iUH15-Explanation of PCB antenna issues

Resistance position of the module
used in iUH15 (Option 1)

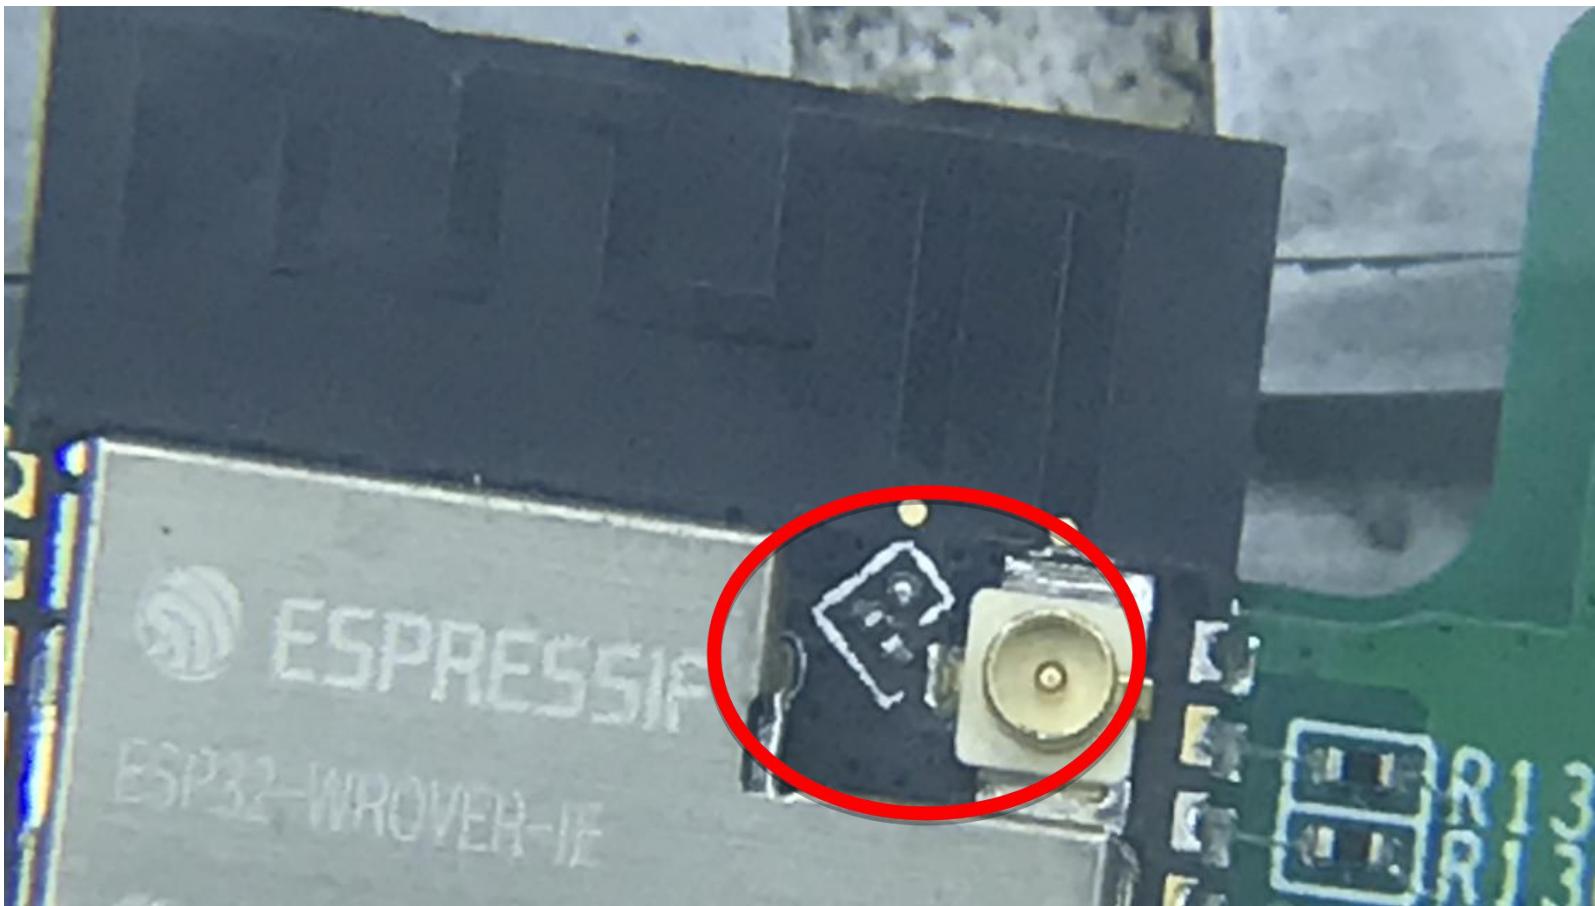
During the design of this module, a selectable antenna scheme was proposed: one is the scheme of external FPC antenna (Option 1), and the other is the scheme of PCB board antenna (Option 2); Two schemes are switched through a resistance during module production;

The module used in iUH15 is an external FPC antenna scheme (Option 1), and the resistance used in the product has already fixed the position, which cannot be switched through software. Therefore, there is no need to conduct additional PCB antenna testing.
